Safety Evaluation Report

Renewal of the Facility Operating License for the
University of Missouri-Columbia Research Reactor

Docket No. 50-186

U.S. Nuclear Regulatory Commission

Figure 11-1 Ar-41 production during MURR operation conditions

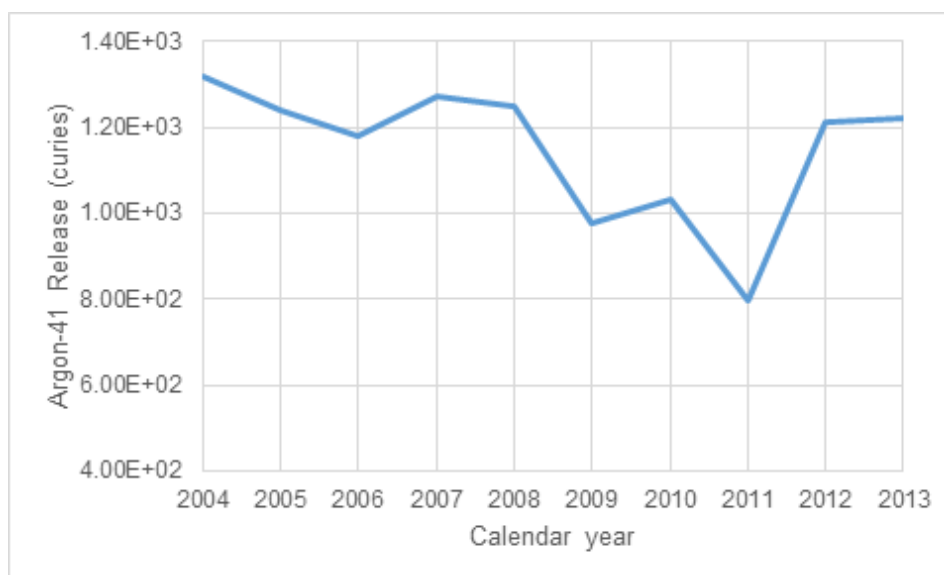
The NRC staff reviewed the analyses provided in the SAR and responses to RAI related to public doses from Ar-41. The NRC staff reviewed the licensee's calculation methodologies and assumptions, and finds that they are conservative and consistent with accepted industry practices, except for the DCF used. The NRC staff used appropriate DCFs in its confirmatory calculations of the dose from Ar-41 to members of the public at the nearest residence and the EPZ boundary. Based on the confirmatory analyses that demonstrate that public doses from MURR routine Ar-41 releases would be within 10 CFR Part 20 limits, and the NRC staff's review of historical Ar-41 releases at the facility as described in the licensee's annual operating reports, the NRC staff concludes that the licensee's Ar-41 releases are acceptable for the renewal period.

Figure 12-1 TS Figure 6.0

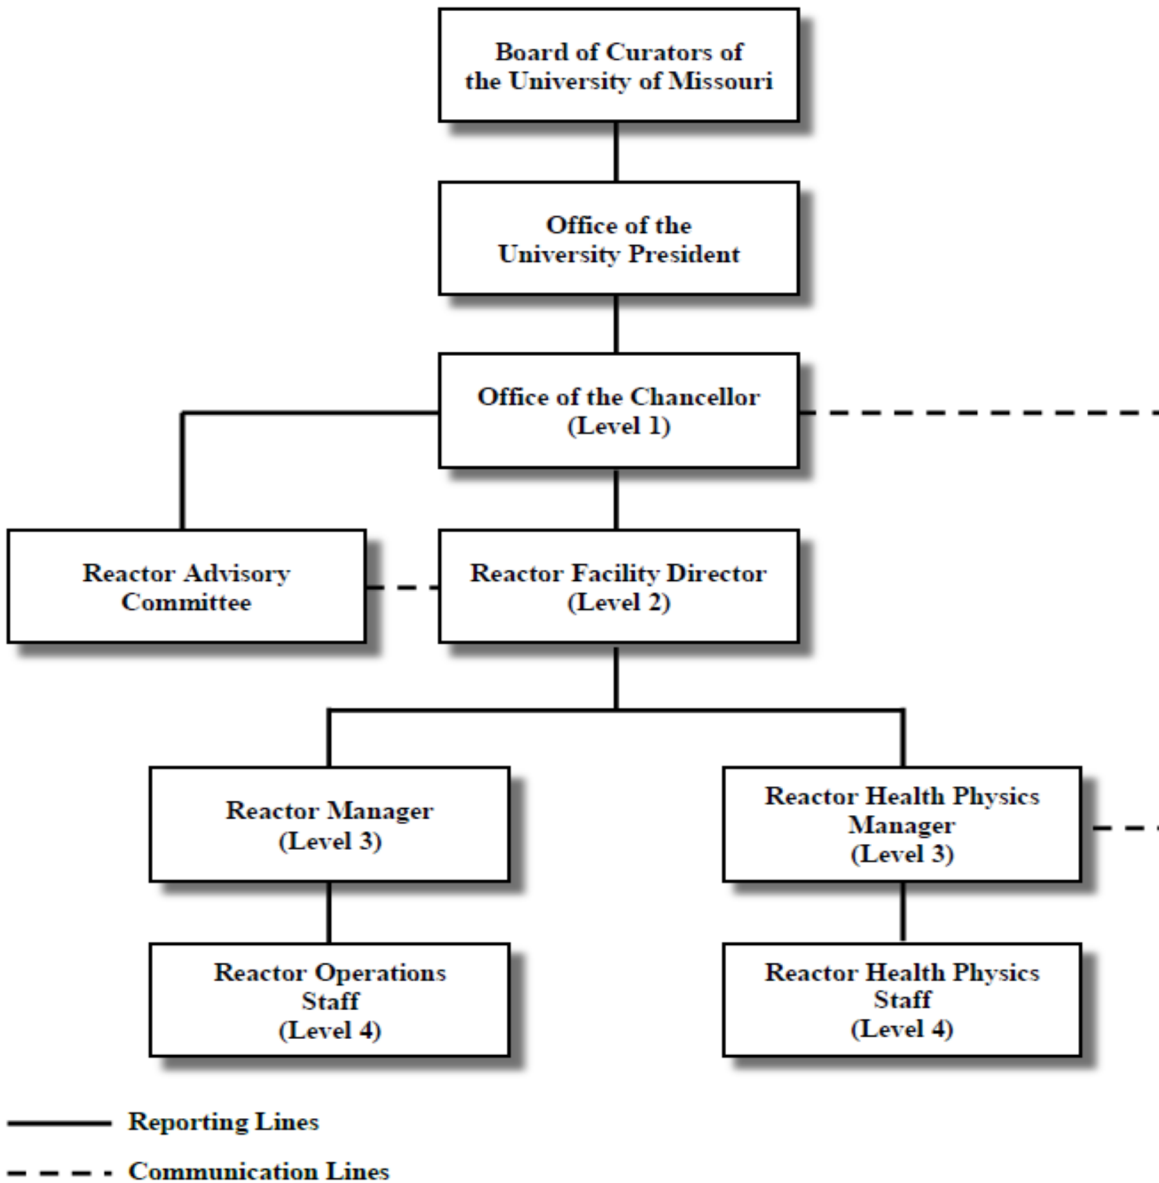
TS 6.1, Specification a, requires the MURR organization structure to be organized as shown in TS Figure 6.0. The NRC staff finds that this specification helps ensure that the TS properly delineates the MURR organization structure, including the communication and reporting lines. The NRC staff finds that the MURR organizational structure TS Figure 6.0 is consistent with the guidance in NUREG-1537, "Guidelines for Preparing and Reviewing Applications for the Licensing of Non-Power Reactors," issued February 1996 (Ref. 51), and American National Standards Institute/American Nuclear Society (ANSI/ANS)-15.1-2007, "The Development of Technical Specifications for Research Reactors," issued 2007 (Ref. 57). Based on the information above, the NRC staff concludes that TS 6.1 and TS Figure 6.0 are acceptable.

Figure 13-1 Benchmark of loss of flow accident

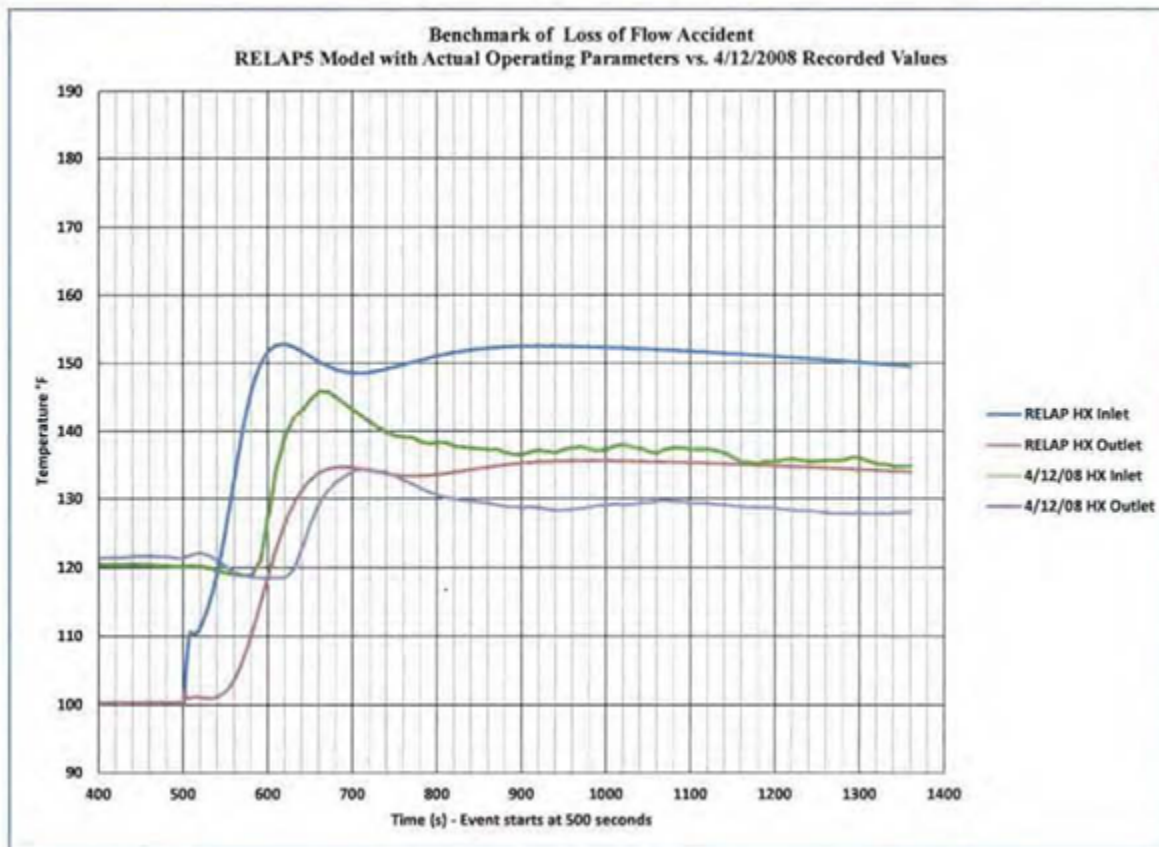
In its response to RAI No. 13.4.b (Ref. 27), the licensee provides two figures showing the benchmarked results using the conservative and the actual operational parameters in the MURR RELAP model. Table 13-7, which is presented graphically in Figure 13-1, show very similar temperature response times between the loss of flow event recorded on April 12, 2008, and the RELAP5-modeled LOFA using the actual operating values listed. The temperature peaks for the RELAP5-modeled LOFA are very close to the actual event. The event starting point in the figure corresponds to 500-second. However, there is a difference in starting temperatures before the event begins. The RELAP5-modeled transient starts with the same in-pool HX coolant inlet and outlet temperatures as the reactor pool water temperature of 100.2 °F (37.9 °C). The assumption in RELAP is that the in-pool HX isolation valves are closed. This condition is true, but it does not consider a ½-in-diameter (1.27-cm-diameter) bypass line around each isolation valve. These bypass lines allow very limited amounts of the primary coolant with a temperature of about 120 °F (49 °F) (inlet temperature) to flow through the in-pool

HX during normal operation. The exit temperature is at 121 °F (49.4 °C) because of the effect of the core exit flow, which directly connects with the HX outlet-piping header.

In addition, the higher temperature difference between the in-pool HX coolant inlet and outlet temperatures in the RELAP5 model indicate that transfer of heat from the PCS coolant through the inner and outer pressure vessels and into the reactor pool is greater than that provided by the RELAP5 modeling because of the limitations of the one-dimensional flow code. This also supports how conservative the RELAP5-modeled LOCA is. In the LOCA analysis, no coolant flows through the in-pool HX. All of the heat transfer from the PCS around the reactor core region is through the inner and outer pressure vessels.
